Sundry Notices and Reports on Wells

Surf: Unit C (NENW), 1034' FNL & 1336' FWL, Section 29, T27N, R04W, NMPM
BH: Unit E (SWNW), 1945' FNL & 410' FWL, Section 29, T27N, R04W, NMPM</p> | <p>5. Lease Number
SF-080674</p> <p>6. If Indian, All. or
Tribe Name</p> <p>7. Unit Agreement Name
San Juan 27-4 Unit</p> <p>8. Well Name & Number
San Juan 27-4 Unit 52N</p> <p>9. API Well No.
30-039-30488</p> <p>10. Field and Pool
Basin Dakota
Blanco Mesaverde</p> <p>11. County and State
Rio Arriba Co., NM</p> |

| ☒ Notice of Intent | ☐ Abandonment ☐ Change of Plans ☒ Other - Change of plans |

SAN JUAN 27-4 UNIT 52N

Project: SAN JUAN BASIN
 Site: SEC 29-T27N-R4W
 Well: SJ 27-4 #52N
 Wellbore: Original Hole
 Design: Plan #1

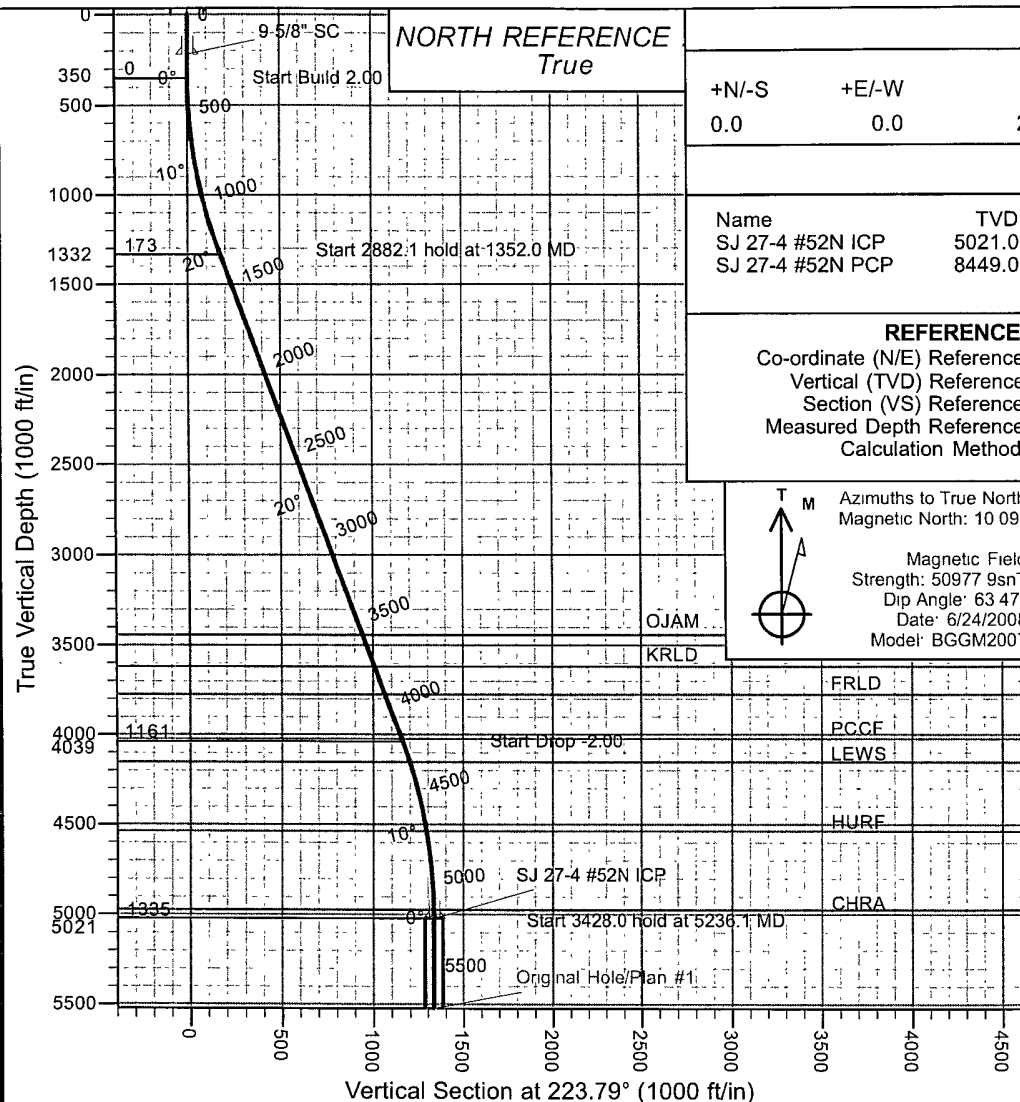
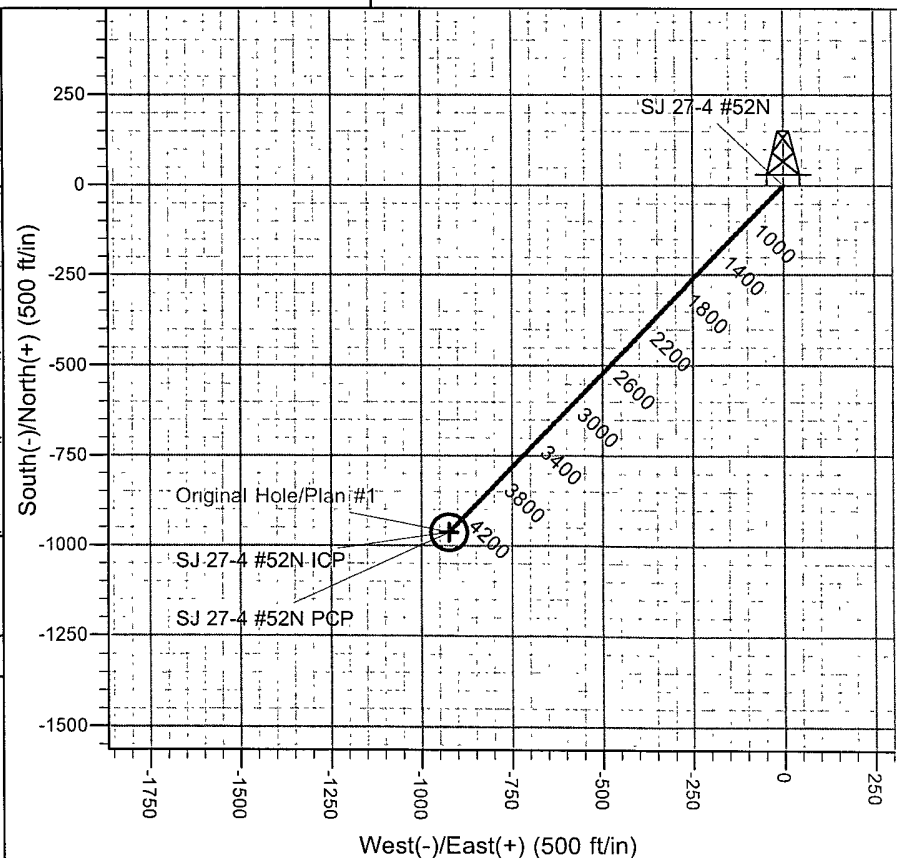
Burlington wished to deepen the intermediate hole from 4521' TVD to 5021' TVD to be able to build & hold small angles which will reduce ~~torque~~ when drilling air hole.

Directional Plan will change also.

Attached is a new Directional Drill plan & Project Proposal.

Sec	MD	Inc	Azi	TVD	+N/-S	+E/-W	DLeg	TFace	VSec	Target
1	0.0	0.00	0.00	0.0	0.0	0.0	0.00	0.00	0.0	
2	350.0	0.00	0.00	350.0	0.0	0.0	0.00	0.00	0.0	
3	1352.0	20.04	223.79	1331.7	-125.2	-120.0	2.00	223.79	173.5	
4	4234.1	20.04	223.79	4039.3	-838.1	-803.6	0.00	0.00	1161.1	
5	5236.1	0.00	0.00	5021.0	-963.3	-923.6	2.00	180.00	1334.5	SJ 27-4 #52N ICP
6	8664.1	0.00	0.00	8449.0	-963.3	-923.6	0.00	0.00	1334.5	SJ 27-4 #52N PCP
